#### 183rd session

## Proposal for Supplement 3 to the original version of UN Regulation No. 152 (AEBS for M<sub>1</sub> and N<sub>1</sub>)

### Submitted by the Working Party on Automated/Autonomous and Connected Vehicles \*

Figure 1

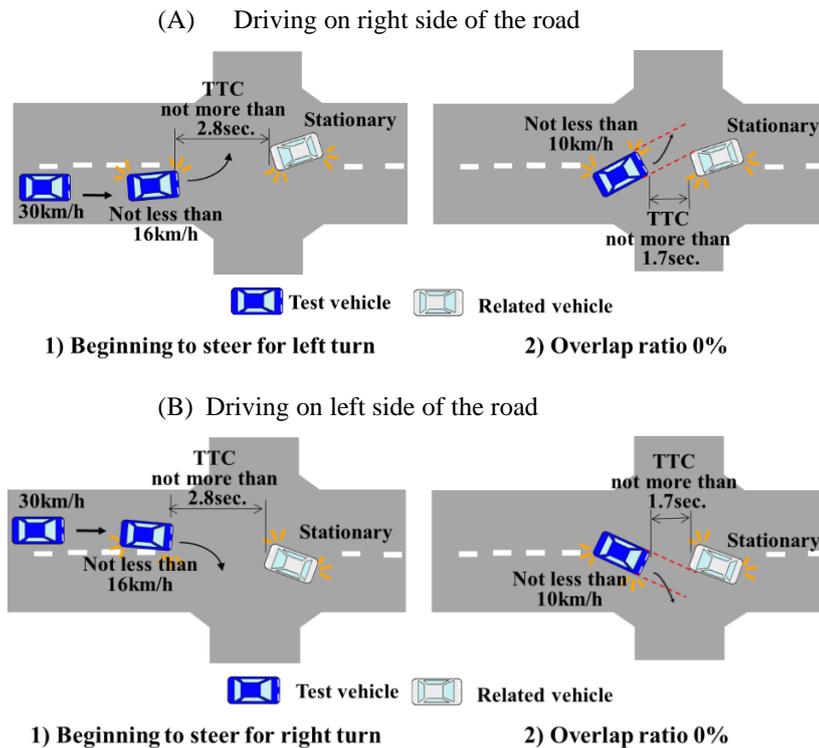
- 1.1. In this scenario, the subject vehicle passes by a left turn or right turn in front of an oncoming vehicle that is stopped to make a left turn or right turn at an intersection.

The subject vehicle drives at a speed of 30 km/h (with a tolerance of +0/-2 km/h) toward the intersection, and decelerates by braking to a speed of not less than 16 km/h at a point where the subject vehicle begins to steer left / right, and the Time To Collision (TTC) to the oncoming vehicle is not more than 2.8 seconds. When the subject vehicle turns left or right in the intersection, the speed is reduced to not less than 10 km/h, and then drives at a constant speed. The TTC to the oncoming vehicle is not more than 1.7 seconds at when the overlap ratio between the subject vehicle and the oncoming vehicle becomes 0 per cent.

Figure 2

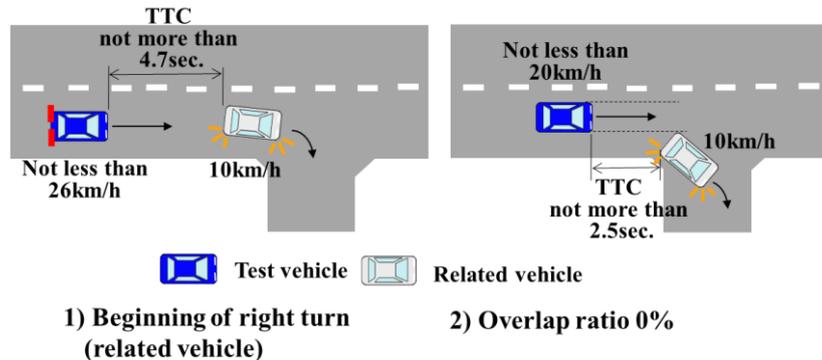
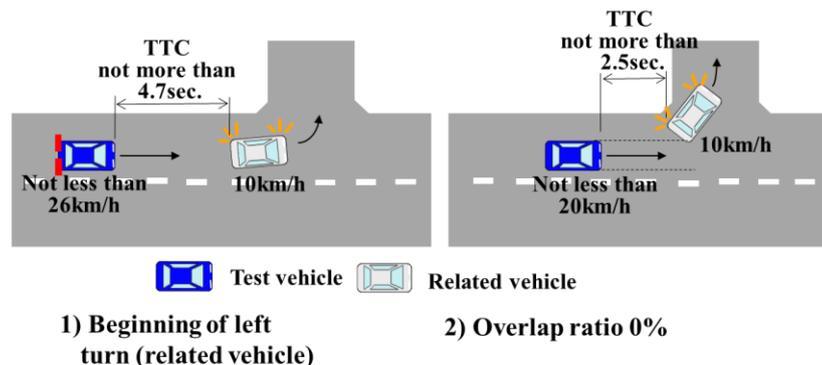
- 2.1. In this scenario, the subject vehicle follows a forward vehicle. After that, the forward vehicle turns right or left at a corner, and the subject vehicle goes straight.
- 2.2. An example of the detail scenario:

Both the forward vehicle and the subject vehicle drive at a speed of 40 km/h (with a tolerance of +0/-2 km/h) on the straight road. The forward vehicle decelerates by braking to a speed of 10 km/h (with a tolerance of +0/-2 km/h) in order to turn right or left at the corner, and the subject vehicle also decelerates by braking to keep appropriate distance with the forward vehicle. At when the forward vehicle begins to turn right or left, the speed of the subject vehicle is not less than 26 km/h and the TTC to the frontal vehicle is not more than 4.7 seconds. After that, the subject vehicle decelerates to a speed of not less than 20 km/h, and then drives at a constant speed. The TTC to the forward vehicle is not more than 2.5 seconds at when the overlap ratio between the subject vehicle and the forward vehicle becomes 0 per cent.

Figure 3  
Curved road with guard pipes and a stationary object

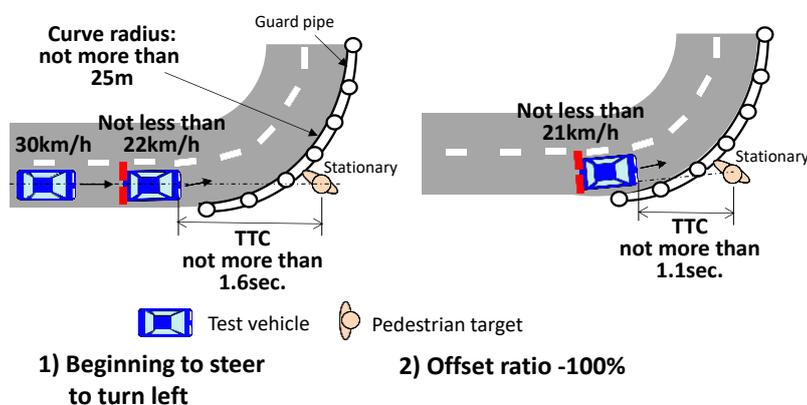
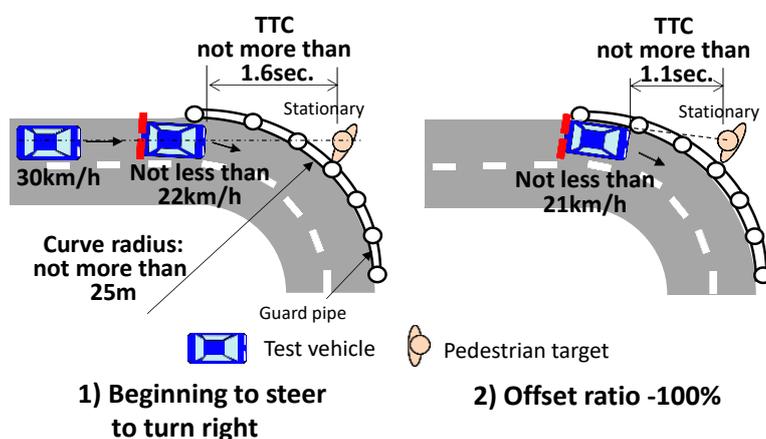
- 3.1. In this scenario, the subject vehicle drives a small radius curved road of which the guard pipes are constructed to the outer side, and a stationary vehicle ( $M_1$  category), a stationary pedestrian target or a stationary bicycle target is positioned just outside of the guard pipes and where on the extension of the centre of the lane.
- 3.2. An example of the detail scenario:

The subject vehicle drives at a speed of 30 (with a tolerance of  $\pm 2$  km/h) km/h toward the curve of which the radius is not more than 25 m at the outer side of the road, and decelerates by braking to a speed of not less than 22 km/h at a point where the subject vehicle enters the curve. The TTC to the stationary object is not more than 1.6 seconds at when the subject vehicle begins to turn in the curve. In the curve, the subject vehicle drives outer lane than the centre of the road. After that, the subject vehicle continue to turn in the curve at a constant speed of not less than 21 km/h. The TTC to the stationary object is not more than 1.1 second at when the overlap ratio between the subject vehicle and the stationary vehicle becomes 0 %, or at when the offset ratio between the subject vehicle and the centre of the stationary pedestrian target or the stationary bicycle target becomes -100 per cent.

Figure 4  
**Lane change due to road construction**

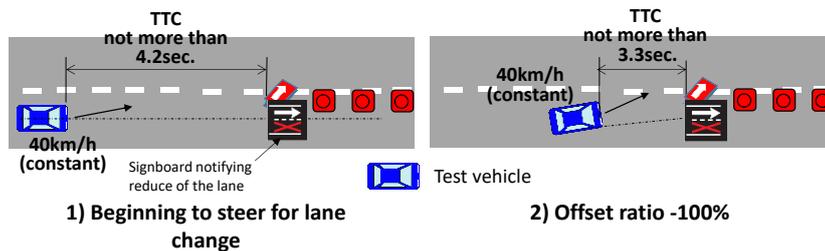
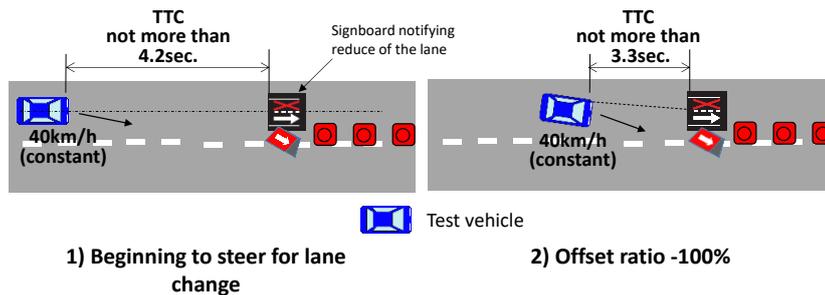
- 4.1. In this scenario, the subject vehicle changes the lane in front of the signboard which is positioned in the centre of the lane and notifies the driver that the lane is reduced.
- 4.2. An example of the detail scenario:

The subject vehicle drives a straight road at a speed of 40 km/h (with a tolerance of  $\pm 2$  km/h), and begins to steer in order to change the lane in front of the signboard which notifies reducing the lane. No other vehicles approach the subject vehicle. The TTC to the signboard is not more than 4.2 seconds at when the subject vehicle begins to steer. During changing the lane, the speed of the subject vehicle is constant, and the TTC to the signboard is not more than 3.3 seconds at when the offset ratio between the subject vehicle and the centre of the signboard becomes -100 per cent.
